Traffic Note Addendum

Land at Chimmens Solar Farm, Mussenden Lane.

Date: March 2024 | Pegasus Ref: P22-1221_R002 RevA_TR_AJ_JB

- 1.1. This Traffic Note Addendum document has been prepared by Pegasus Group on behalf of RES Ltd (the Applicant) in relation to the planning application for a solar farm at Chimmens Solar Farm, Mussenden Lane (Ref: 23/O3181/FUL).

Plate 2.1 – Proposed Temporary Public Footpath Diversion Route

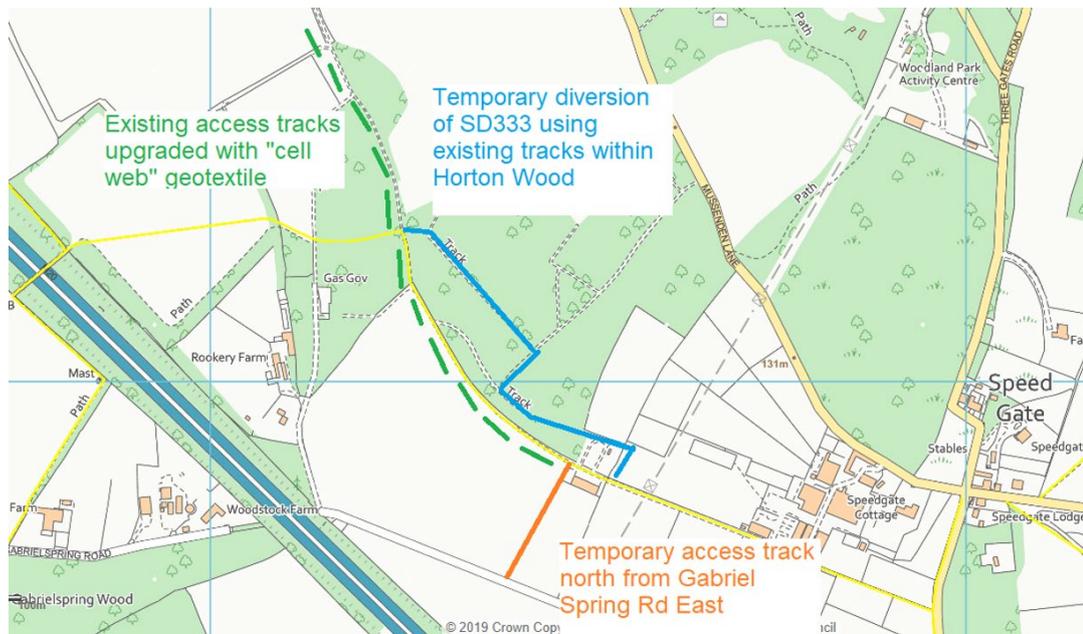
2. *Site access during construction and operation appear to be aligned along Public Footpath SD333*
 3. *Insufficient detail regarding PROW incorporation to enable full comment, insufficient weight given to user amenity of PROW routes.*

- Omission of reference to one of the above PROW routes, SD332, within Application documents
- Site access during construction and operation appear to be aligned along Public Footpath SD333
- Insufficient detail regarding PROW incorporation to enable full comment, insufficient weight given to user amenity of PROW routes

- 2.11. Within the Planning Addendum document, it has acknowledged that during the construction period traffic will be routed along the existing track through the site which correlates with the alignment of Public Footpath SD333.
- 2.12. To resolve this, the applicant is proposing a temporary diversion route for the construction period as detailed below. This will enable the public to continue to utilise tracks and the onwards PROW network safely during this construction period. It is proposed that this alternative route will be clearly signposted for ease of use.

- 2.13. It was agreed with KCC that the alternative routing could be confirmed post application and that, if necessary, the alternative route could be amended to any such similar route depending on the construction phase and activities as long as construction traffic and the general public have separate routes. As such there would be no concern regarding user safety.
- 2.14. It is understood that the temporary closure and realignment will be agreed with Kent County Council under a separate agreement prior to any works commencing on site and can be secured by condition if necessary. As it typical of any PROW diversion, notices will be given on site giving advance warning of the diversion.

Plate 3.1 – M23 Junction 3 Swanley Interchange – Collision Assessment Area

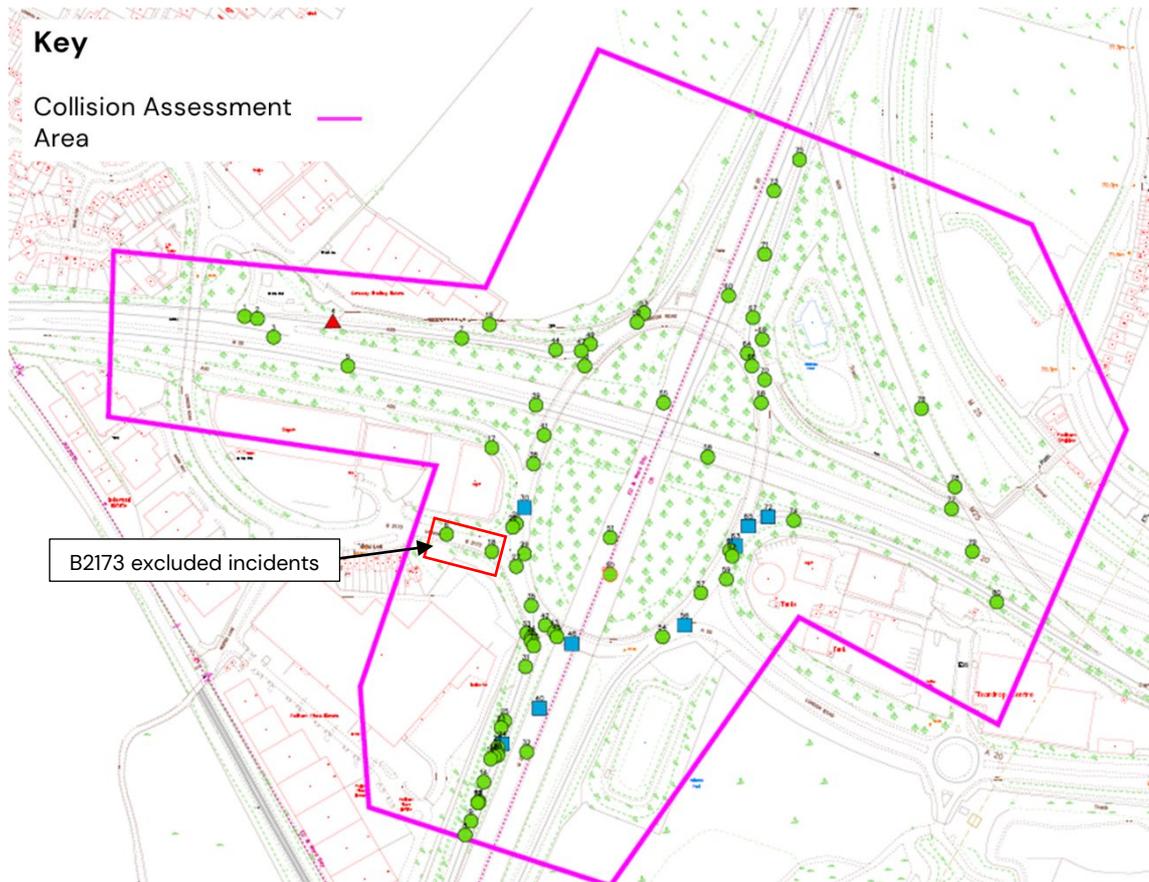
- 3.7. NHH, who operate the M25 and M20, requested that collision assessment area is extended beyond that provided in the CTMP to include M25 Junction 3 Swanley Interchange, where development construction traffic is proposed to route to/from the Strategic Road Network.
- 3.8. It is worth noting that construction traffic will be temporary in nature spanning a total of 6-12 months with a maximum of 30 two-way trips per day. This level of traffic increase at a busy motorway interchange will be well within the typical daily variation of traffic flows for the junction.
- 3.9. Nevertheless, in order to satisfy any concerns NH may have in regard to the highway safety of the junction and to consider the potential impact of temporary construction traffic within the study area a review has been undertaken and is set out in the following paragraphs.

- 3.10. STATS19 Personal Injury Collision (PIC) data has been obtained from KCC for the eight year period requested (01 January 2015 – 30 September 2023), covering five years pre-pandemic and all available post-pandemic years.
- 3.11. **Plate 3.1** illustrates the collision assessment area and PIC locations with the full data outputs provided in **Appendix C**.

- 3.12. A total of 80 collisions were recorded within the study area and for the entire period.
- 3.13. Two incidents on the B2173 can be discounted from the analysis as this road does not form part of the construction traffic route.
- 3.14. Whilst all incidents are unfortunately regrettable, the majority (69) of incidents were classified as minor, eight were serious and only one was fatal.
- 3.15. Construction vehicles will use the A20 approach onto and from Junction 3 of the M25. Only one collision was recorded at the A20 approach which construction vehicles are proposed to use. The incident whilst classified as serious was the result of a circulating vehicle failing to stop at a red light. As such there is no common causation factor or trend of accidents on this approach which would be exacerbated by the traffic associated with the development.

Plate 4.1 – PIC study area

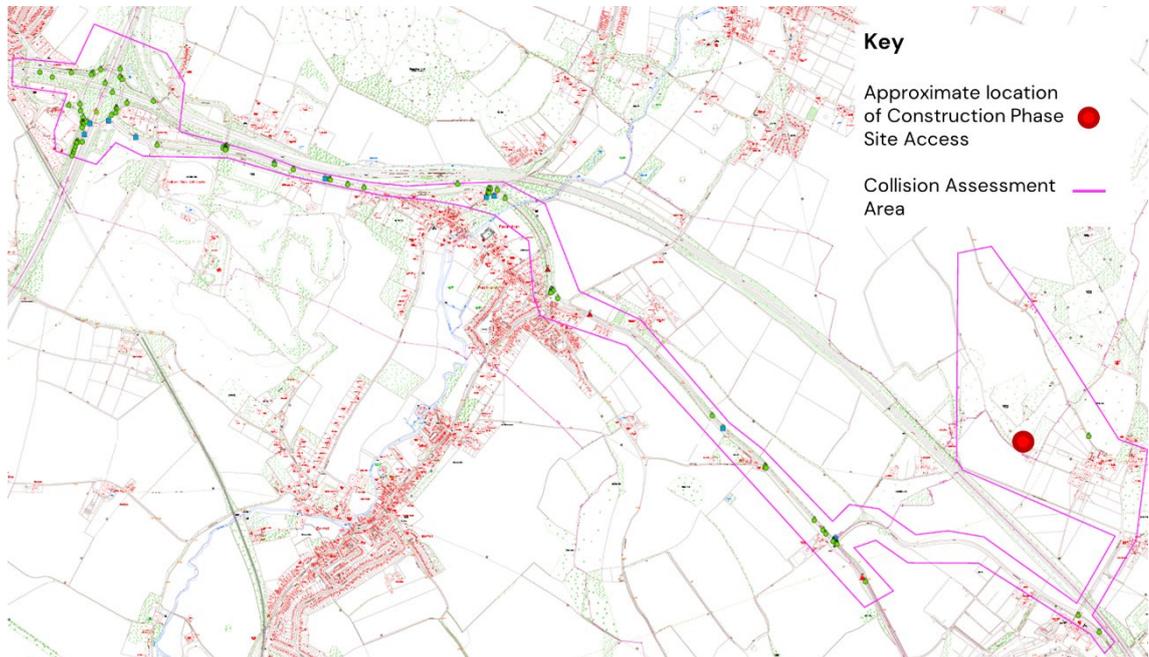
"there are clusters of PICs at the junction of A20/Scratchers Lane, with two nearby fatalities reported and further PIC clusters and fatalities on the highway network – on the A20 between M25 J3 and M26 J2a, which had not been accounted for and that the level of PIC data provided within the CTMP report did not consider the full impact of the proposed development".

- 4.21. Based on this, the following sections sets out the additionally required PIC data which covers the latest five-year period (01 October 2018 – 30 September 2023). The data provided by KCC is provided in **Appendix F**.
- 4.22. The area of study set out in **Plate 4.1** below covers the construction route from the M25 Junction 3 Swanley Interchange (M25 Junction 3) to the proposed development site, via the A20. The below analysis excludes the M25 Junction 3 Swanley Interchange which is analysed separately above in response to NHs comments where it was concluded there was no highway safety concern associated with the junction. The study area considers the full extent of the construction route beyond which trips will dissipate across the Strategic Road Network.

- 4.23. The PIC data indicates a total of 49 collisions within the study area. Of these collisions there were three fatal collisions all located on the A20, nine serious collisions and 37 slight collisions.
- 4.24. Of these total collisions across the five-year period, 13 collisions involved goods vehicles over 3.5 tonnes (27% of recorded collisions) and only two of these were HGVs (4% of recorded collisions). The construction traffic associated with the site will be a combination of vehicles from cars/vans up to 16.5m articulated HGVs.
- 4.25. Many of the accidents can be attributed to driver behaviours, with there being multiple instances of vehicles failing to slow down in time for stationary traffic, and in some cases this leading to multiple vehicles being affected by this.
- 4.26. The number of collisions per year are summarised in **Table 4.4** below.

Figure 9 OP 34 Street View toward Proposed Development (April & October)

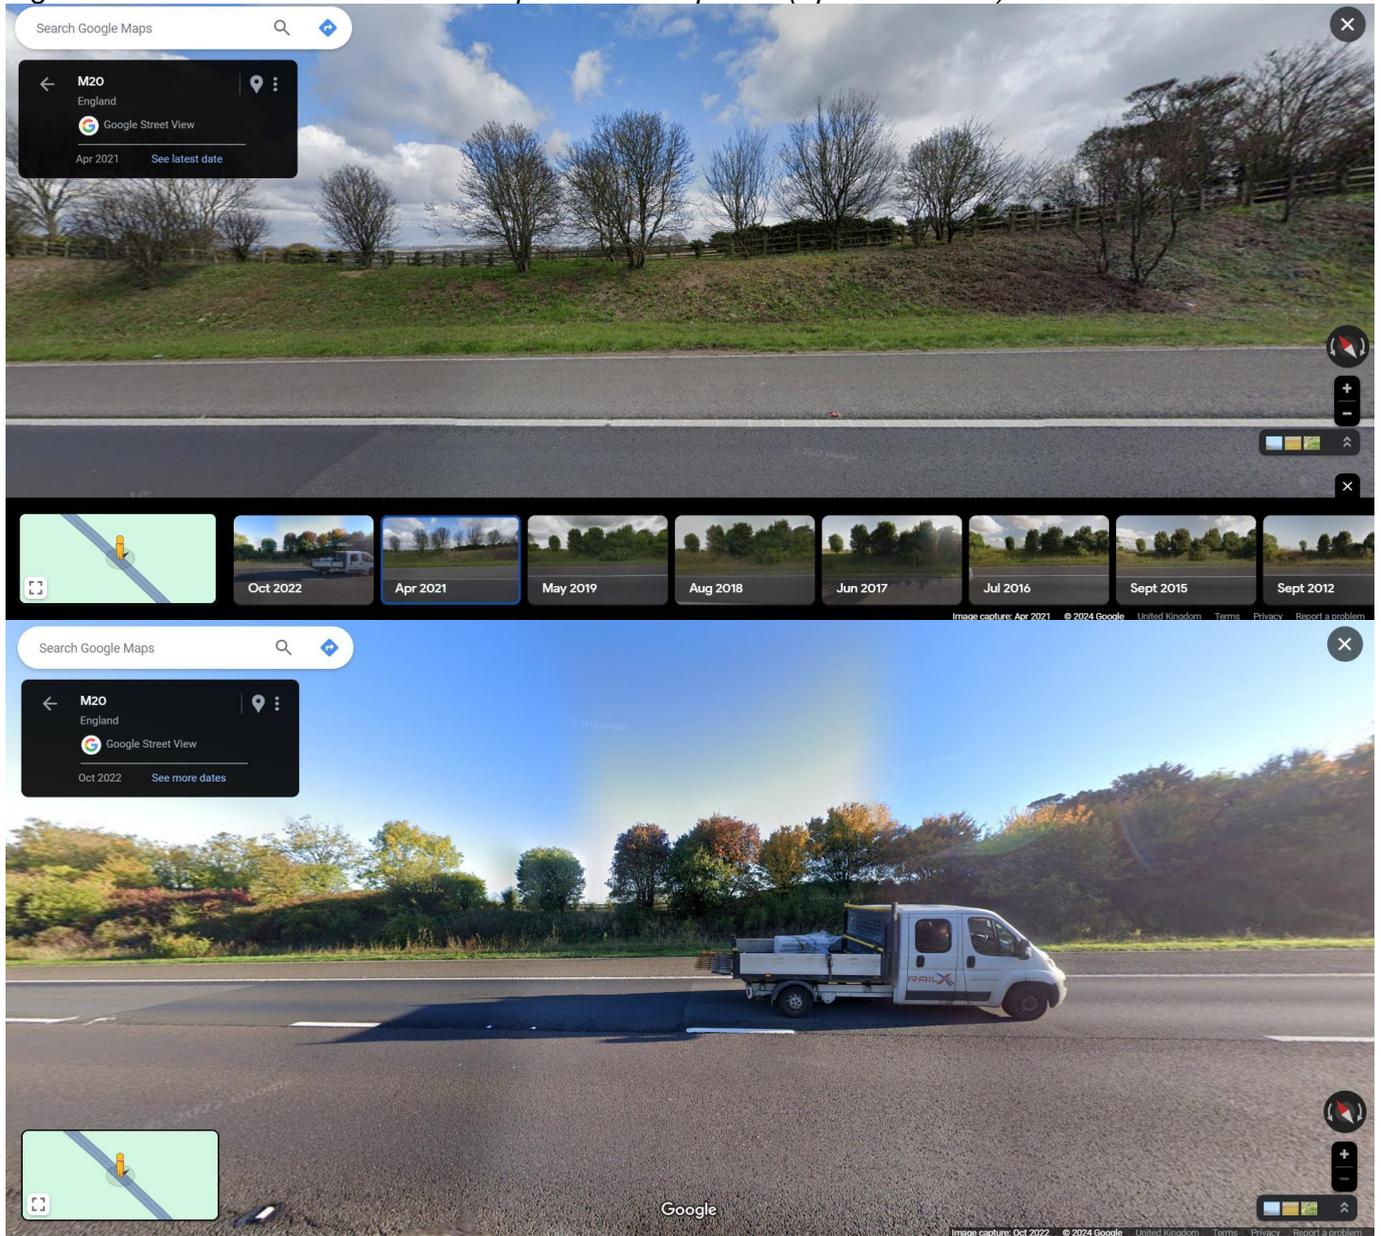
Page	Description	Comment
		<p>previously states that the length of road affected can also be considered in determining the significance of impact.</p> <p>The report describes the sections of road where solar reflections are experienced, and where the glare originates from.</p>
28/37	Modelling Results & Interpretation (continued)	<p>The report states that arrays 4 and 5 are closest to the M20 and therefore has the biggest impact. Pager Power considers this dismissive of elevated road users (such as HGV drivers) where arrays behind these arrays will be visible and still could have an impact.</p> <p>The modelling result suggests solar reflections will only be geometrically possible towards a very short section of the assessed road. Based on Pager Power's industry experience, this would not be predicted.</p>
29/37	Modelling Results & Interpretation (continued)	<p>Pager Power considers the conclusion of existing vegetation and topography to mitigate the impact upon road users travelling west to east justified.</p>

Therefore, it is considered reasonable to assign a ‘low impact’ significance to road users along this section of the M20.

Whilst additional mitigation is not considered to be strictly necessary, installation of opaque fencing or all-year-round vegetation along this specific section of the road could further mitigate potential glare from array PV4, resulting in an ‘insignificant’ residual impact.
